MONTGOMERY COUNTY HISTORIC PRESERVATION COMMISSION
STAFF REPORT

Address:	4728 Dorset Avenue, Chevy Chase	Meeting Date:	7/28/10
Applicant:	James Graham (Anthony Barnes, Architect)	Report Date:	7/21/10
Resource:	Contributing Resource Somerset Historic District	Public Notice:	7/14/10
Review:	Preliminary Consultation	Tax Credit:	None
Case Number:	N/A	Staff:	Anne Fothergill

PROPOSAL: Side bay addition, alterations to pool house, pool construction, and fencing installation

SIDE ELEVATION SKETCH

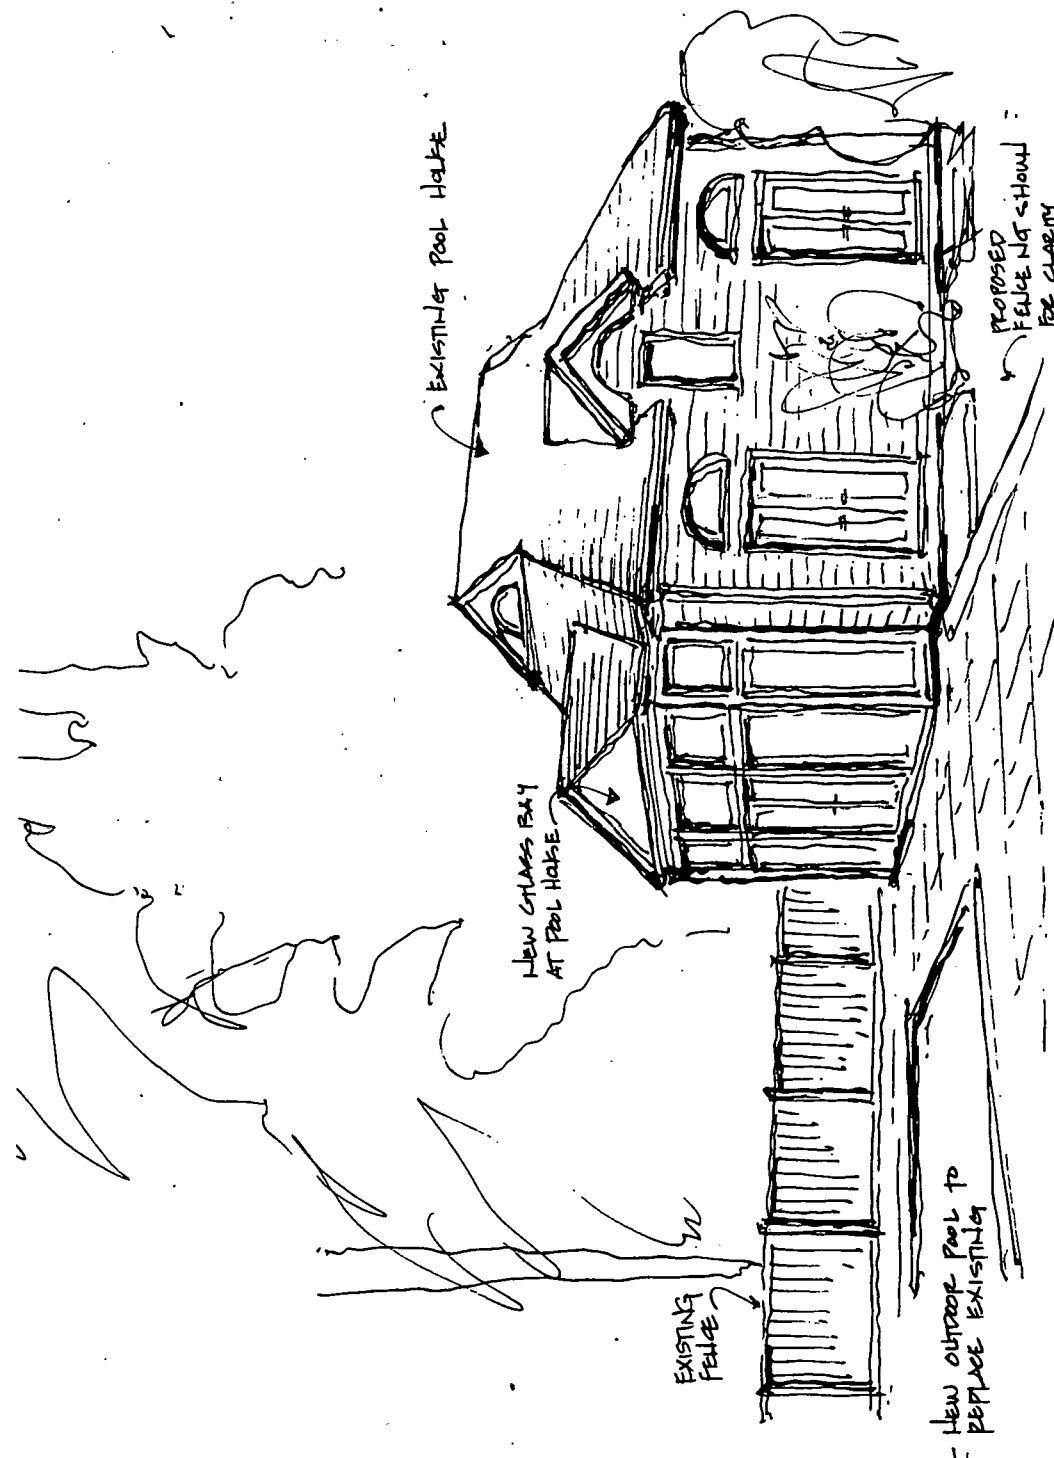
The current proposal is not for a new addition to this house, but to an enlargement of an existing addition that extends off the east (left) side of the house. Based on the design guidelines and the *Standards*, if the existing bay addition were proposed today, staff would be concerned that it seems to compete with and detract from the historic bay on the same side of the house. Thus, staff is concerned about a one-story expansion of this already problematic feature. The enlarged bay as proposed will extend out the left side beyond the historic bay even more than existing conditions. The proposal would change the existing fenestration pattern and add a new, flared roof as another visible feature. Without the existing vegetation as screening, this proposed expanded bay would be visible from the front.

Staff doesn't have concerns about screening the existing second story porch on the east side of the addition but there is some concern about the compatibility of the two new sets of stairs to the patio as proposed.

The applicants have not determined the materials at this preliminary stage but staff would recommend that they select materials that are compatible with the historic house including wood windows and fencing.

POOL HOUSE SKETCH

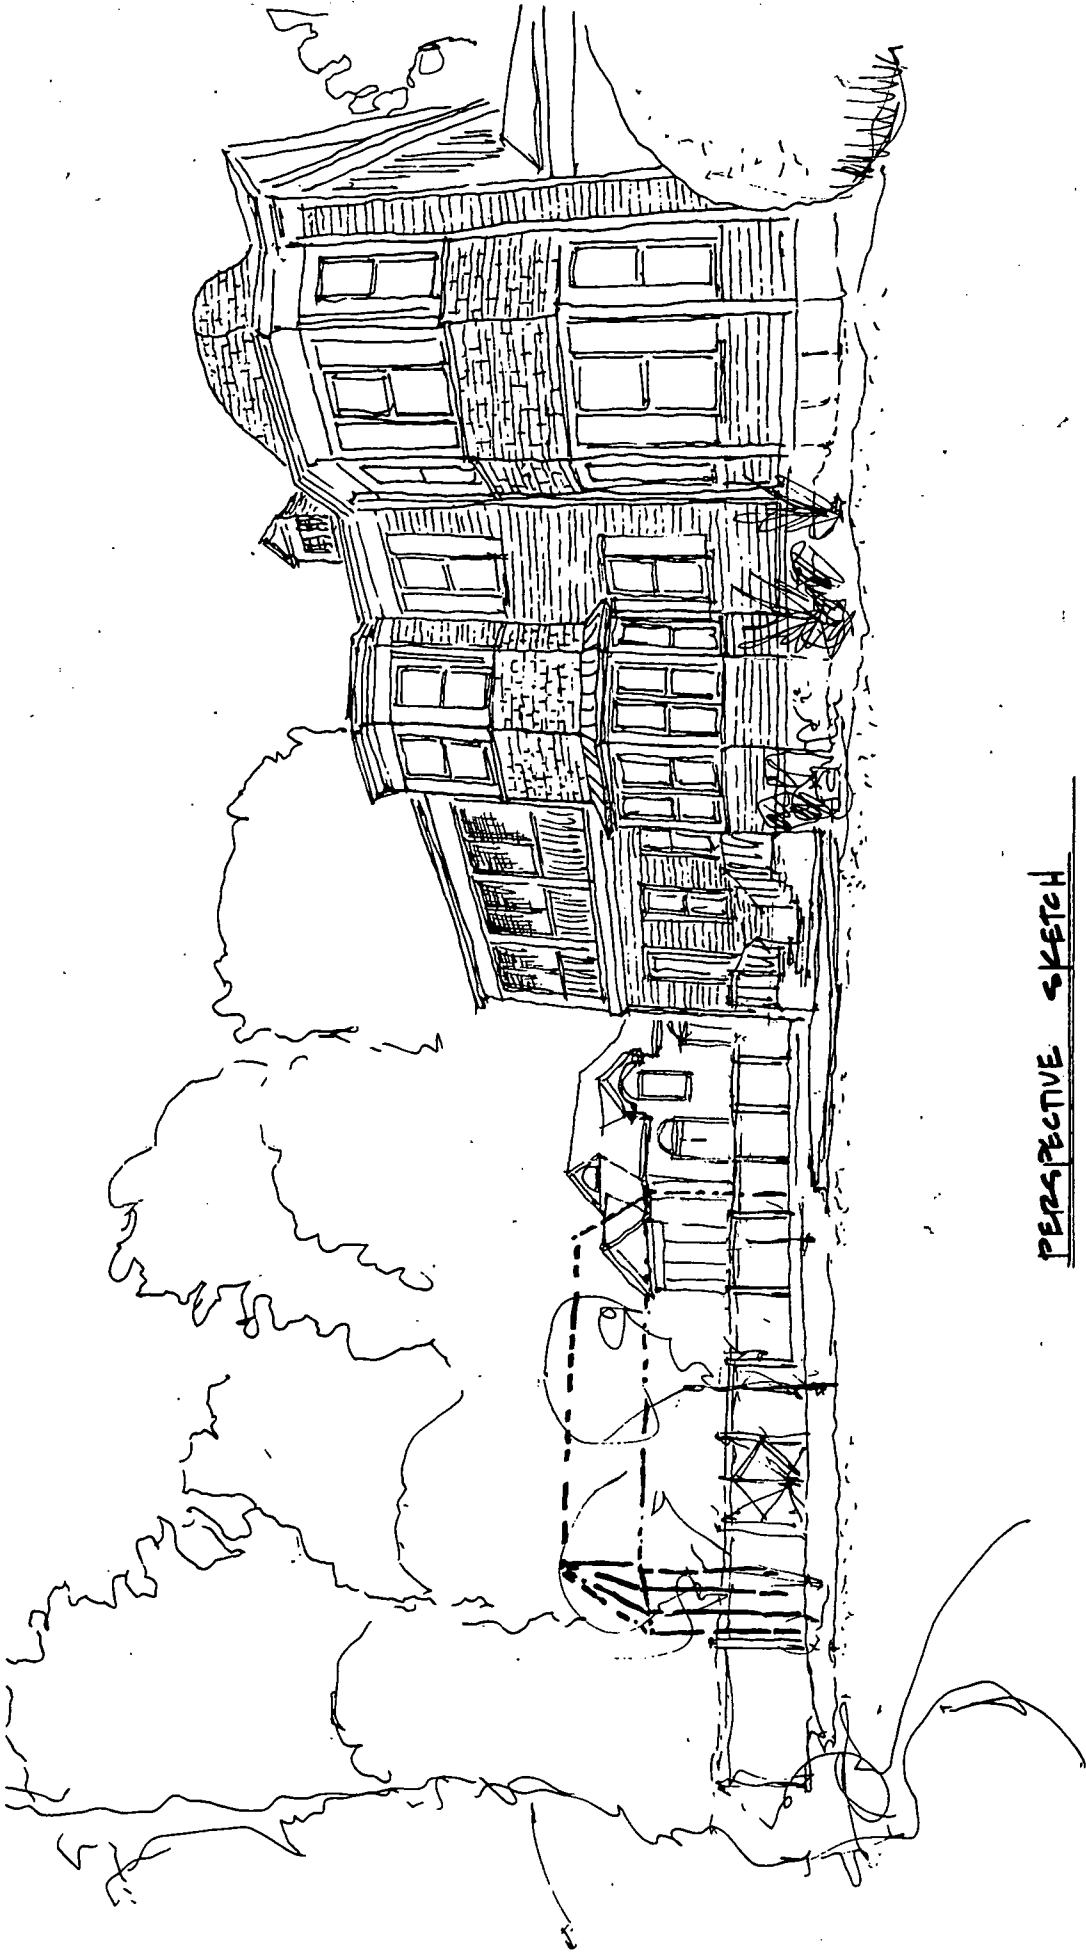
Staff does not have concerns about the alterations to the non-historic pool, pool house, and the installation of fencing around the pool as all these changes are located at the rear of the property and will not have an adverse impact on this historic house or the historic district.
